**METROPOLITAN GOVERNMENT OF NASHVILLE AND DAVIDSON COUNTY**

**STAFF RECOMMENDATION**  
**1430-B Greenwood Avenue**  
**January 17, 2018**

**Application:** New construction – infill and outbuilding (Revision to previously approved plan)

**Description of Project:** Application is to revise a previously-approved infill design and to alter the previously-approved rear setback for the outbuilding.

Figure 2 (left) shows the previously approved site plan and Figure 3 (right) shows the proposed site plan.

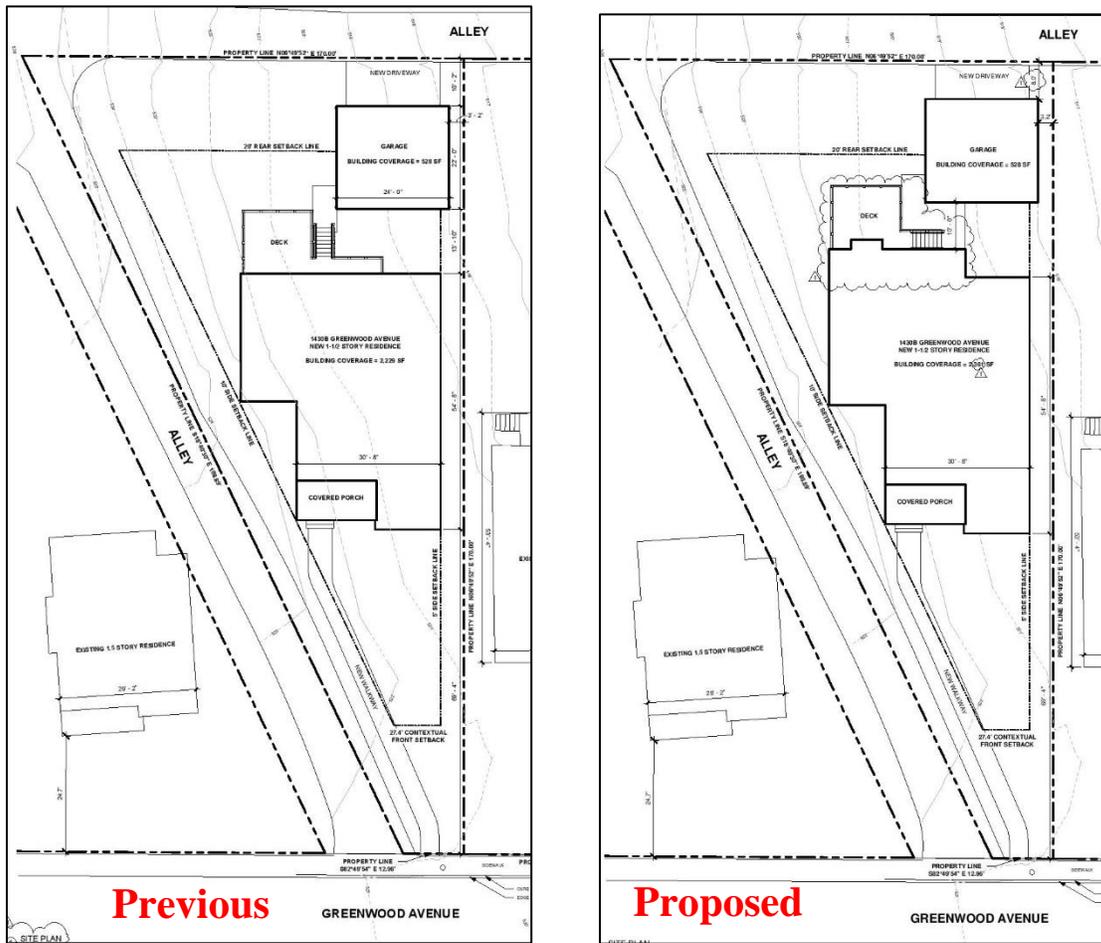
**Height & Scale:** The proposed revisions will not alter the previously-approved height of the house. They will also not extend the width of the house. The applicant proposes to increase the depth of the house from fifty-four feet, eight inches (54'8") to sixty feet, eight inches (60'8"), adding approximately six feet (6') of depth to the rear of the house (Figures 2 & 3). The width of the extension is approximately twenty-nine feet (29'), and therefore, the revision would add approximately one hundred and seventy-four square feet (174 sq. ft.) of footprint to the previously-approved plan. The revision also includes a chimney at the rear but chimneys are generally not counted towards the square footage calculations.

**Setback & Rhythm of Spacing:** The revised plans do not affect the previously-approved front or side setbacks. It will reduce the proposed rear setback from forty-six feet (46') to forty feet (40'). Chimneys are generally not counted in the setbacks. The proposed rear setback meets the base zoning setback of twenty feet (20') and is appropriate given the odd configuration of the site. Since the revision will not affect the front setback, it will not affect the rhythm of spacing along the street. Staff finds that the proposed rear setback is appropriate and meets Section II.B.1.c. of the design guidelines.

There will be ten feet (10') of space in between the back of the house and the outbuilding. Previously there had been thirteen feet, ten inches (13'10") (See Figures 2 & 3). The design guidelines state that there should typically be a minimum of twenty feet (20') in between the primary and outbuilding structures. However, in cases where lots are unusually shallow or unusually shaped, the Commission has approved as little as ten feet (10') in between the two structures. Staff finds that the odd shape of the lot, which requires the infill to have a deep front setback and decreases the buildable space at the rear, renders the ten foot (10') separation appropriate. Staff therefore finds that the revisions meet Section II.B.1.h. of the design guidelines.

Figure 4 (above) shows the previously approved left façade and Figure 5 (below) shows the proposed left façade. Note that the changes to the gable details were approved by MHZC in December.

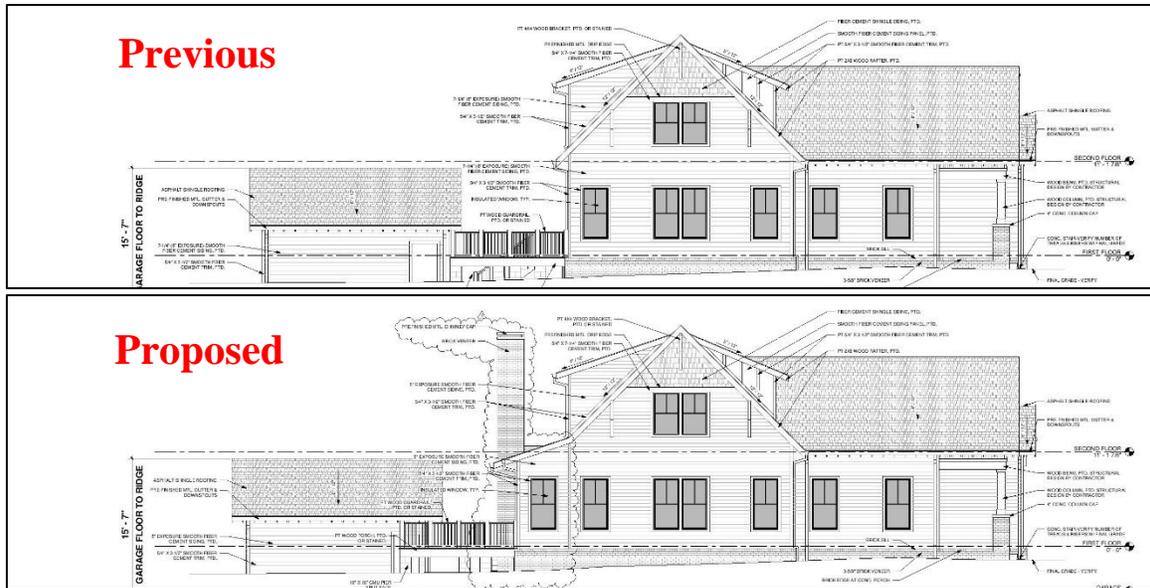
The extended footprint would only affect the first floor. The second story would not be expanded. The proposed extension would be one story with a height of thirteen feet (13') above the foundation and fifteen feet, three inches (15'3") above grade (Figures 4 -9).

Staff finds that the extra six feet (6') of depth and the extra square footage are appropriate and meet the design guidelines. The extra depth occurs over one hundred and twenty feet (120') back from the front property line. It is just one story in height. It will not greatly affect the overall scale of the infill house or how it relates to the overall historic context.

Figure 8 (left) shows the previously approved rear façade and Figure 9 (right) shows the proposed rear façade. Note that the changes to the window openings were approved by MHZC in December.

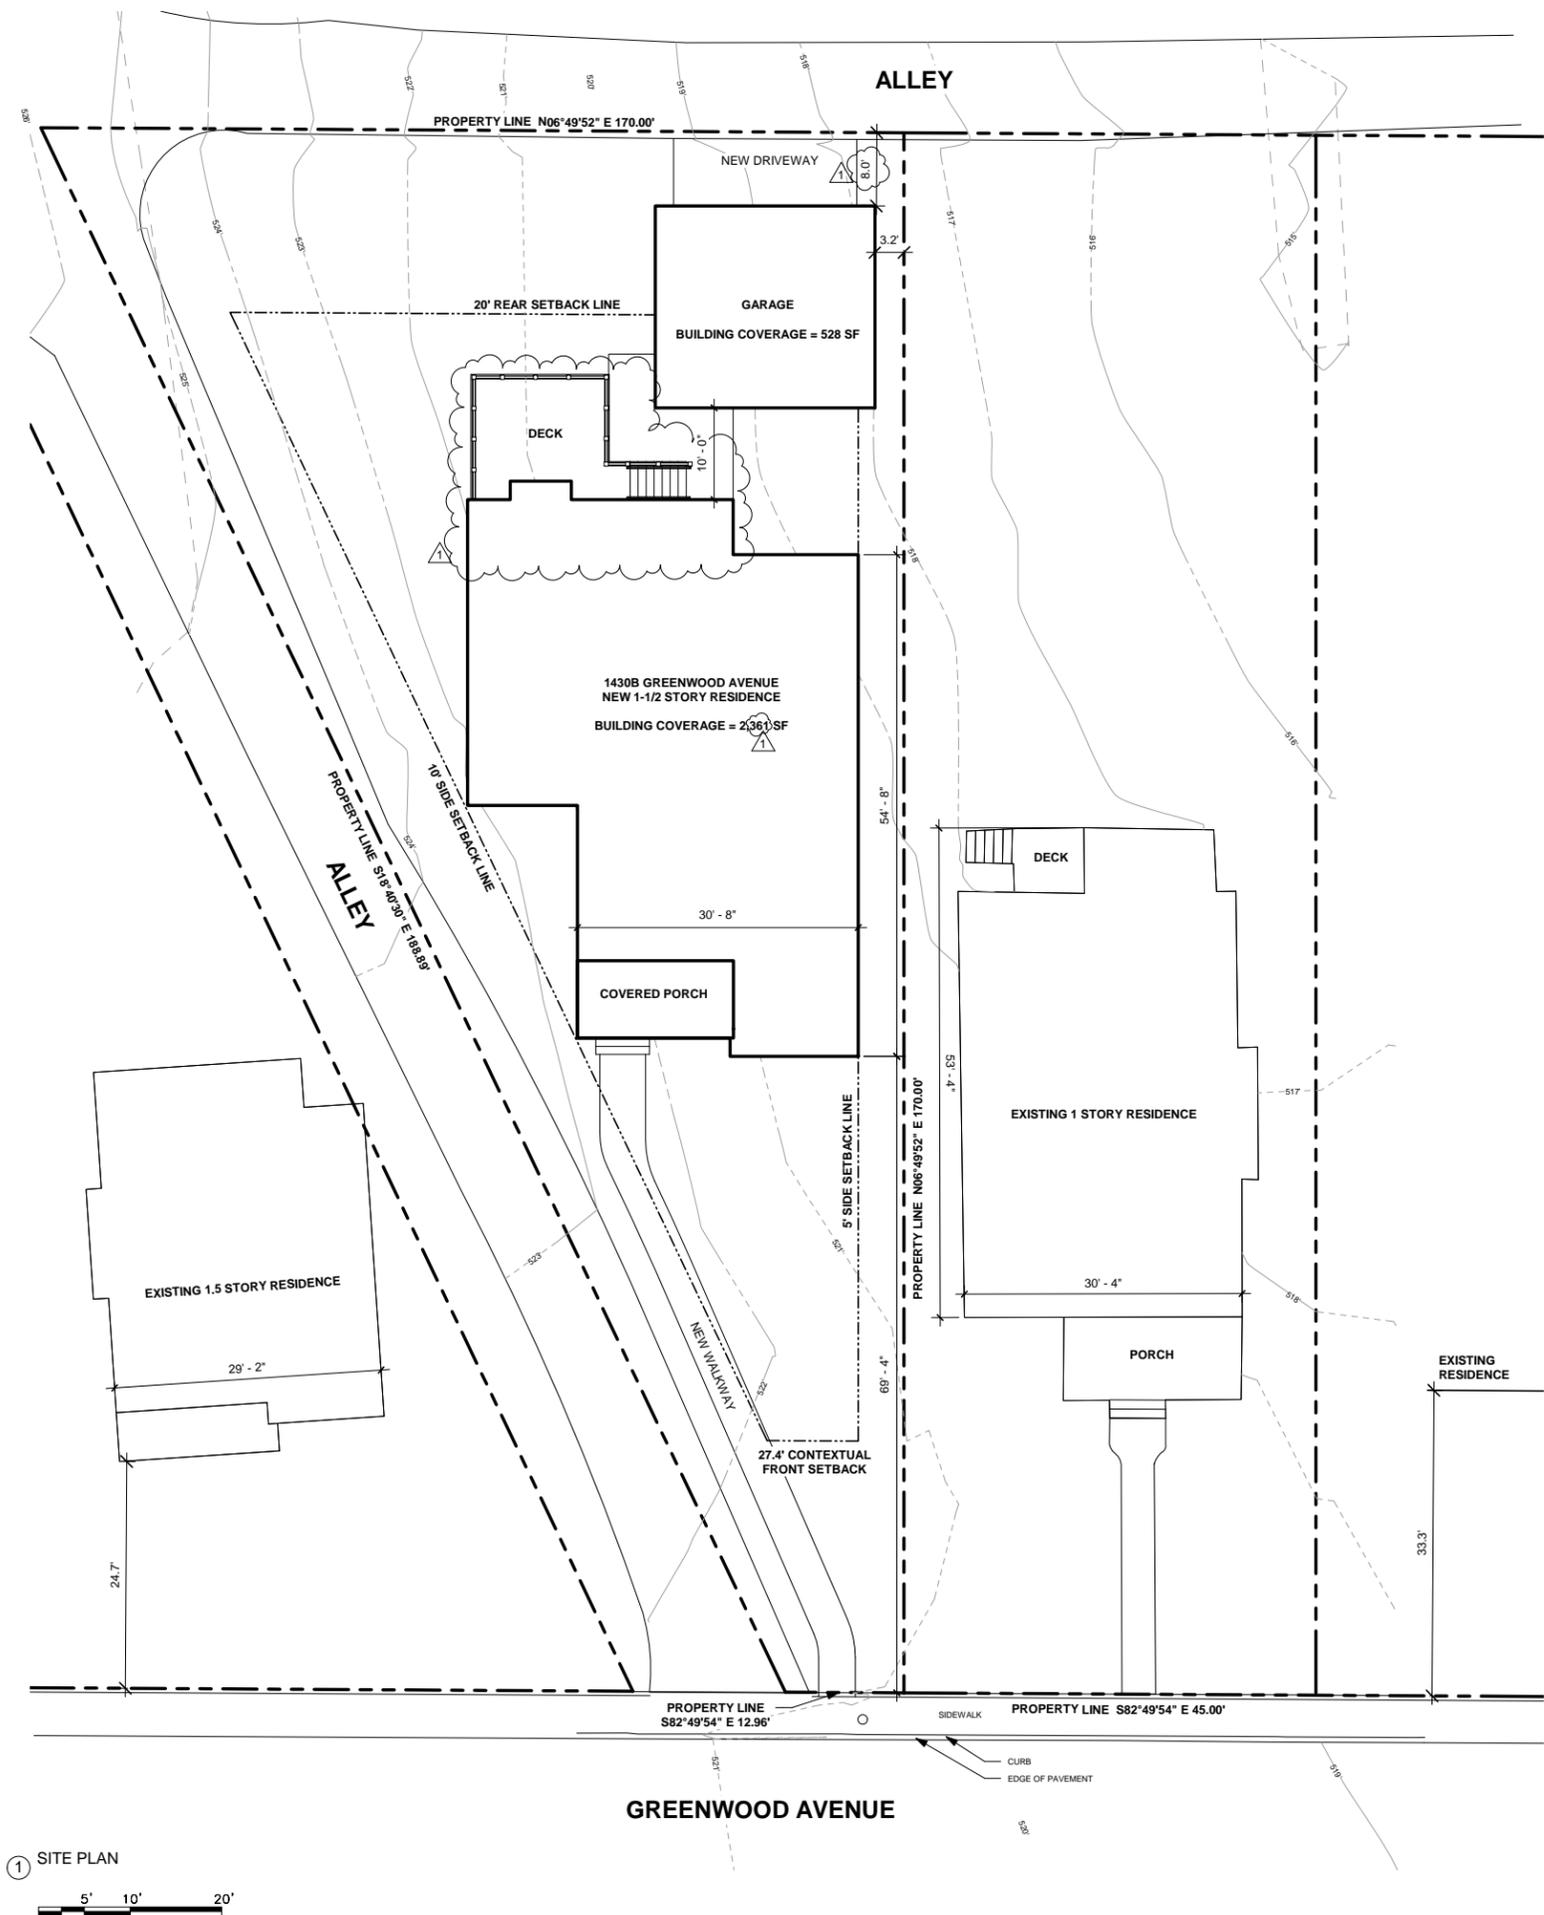
**Materials:** The only change to the previously approved materials is the addition of a rear brick chimney. Staff recommends approval of a brick sample, windows and doors, and the shingle color. With staff's final approval of all materials, staff finds that the known materials meet Section II.B.1.d. of the design guidelines.

**Roof form:** The proposed rear extension has a shed roof with a 3/12 pitch. Staff finds that low-pitched shed roofs are typical on rear extensions. Staff therefore finds that the roof form of the revised project is compatible with the context, and meets Section II.B.1.e. of the design guidelines.
